OS-IN-2019-010 Remove Manual Writings on Tape and Additional Dot-Matrix-Code at Ring Label

Customer Information Package

OS QM CQM ICI | 01.04.2019

A) Remove of manual written "arrow"

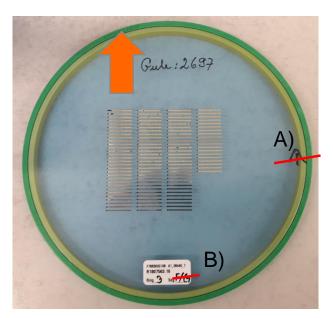
The orientation of chips on tape is clearly definded by the position of the label – always below the chips.

Then the chips are orientated in that way, that the laser diode are emitting ahead.

Additional Dot-Matrix-Code (Only for OSRAM OS internal use)

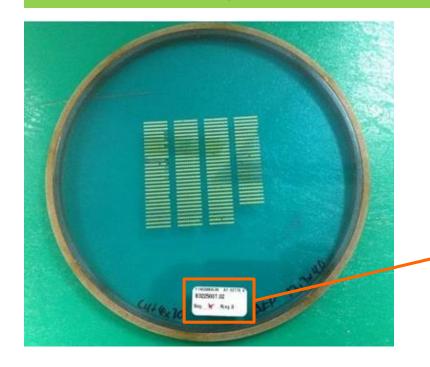
By the additional "Dot-Matrix-Code" the rings can be tracked automated by equipment or reading tools at OSRAM OS production.

NEW:
